Re: Initial Submission Review – The Aurora Highlands North – Area B - Site Plan
Application Number: **DA-2062-33**
Case Numbers: **2022-4027-00**

Initial Submittal Review

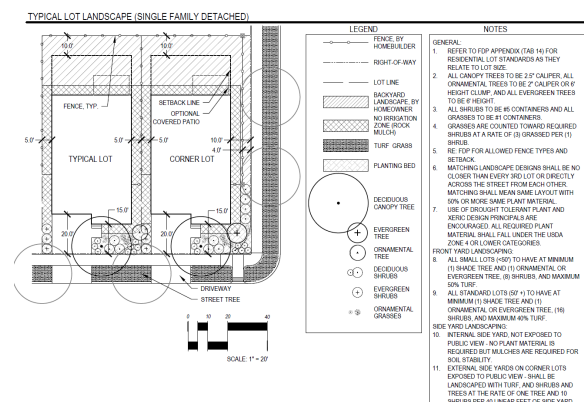
- 3I. Provide separate lot typical diagrams for standard and small single family detached residential lots and for motor courts.
- 3J. Each small residential lot shall incorporate a private outdoor space consisting of a minimum of 180 square feet. Demonstrate on the lot typical diagrams where this will be available for each proposed lot type.

- 3K. Add a Lot Data Table to show the proposed lot sizes/types, minimum dimensions and area, and the required setbacks for each. Are duplex lots included in this site plan? If not, remove lot typical diagrams and all other references.
